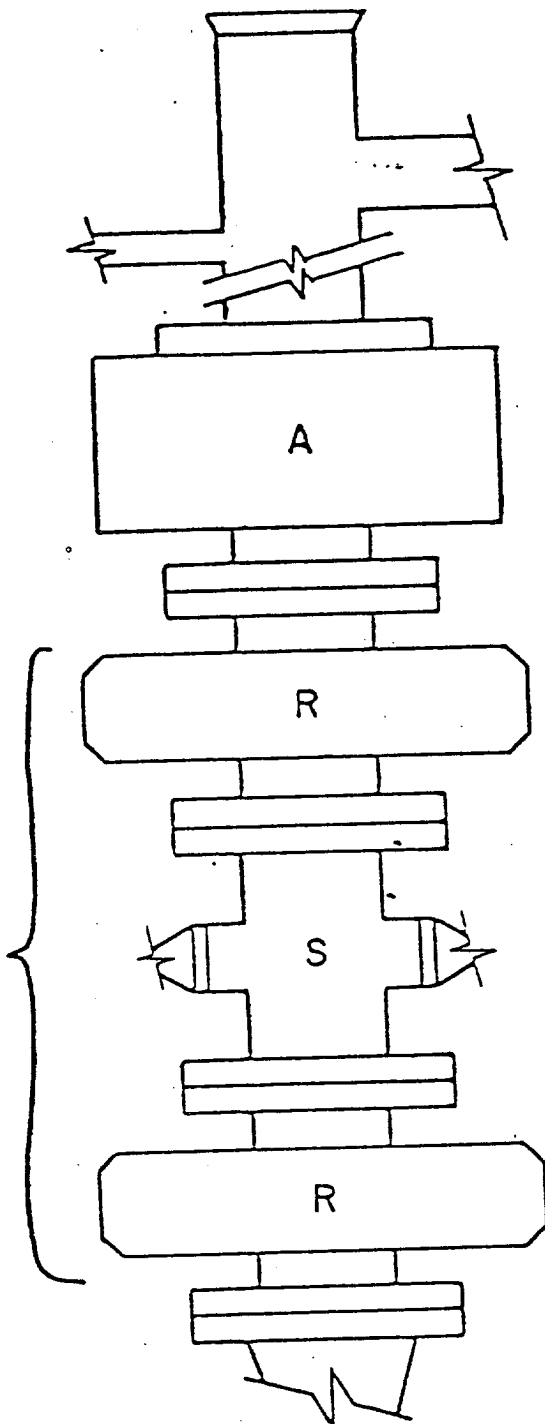
This may be a double  
with a side outlet

NOTE: IT IS RECOMMENDED THAT THE CHOKE LINE BE ATTACHED  
ABOVE THE BOTTOM PREVENTER
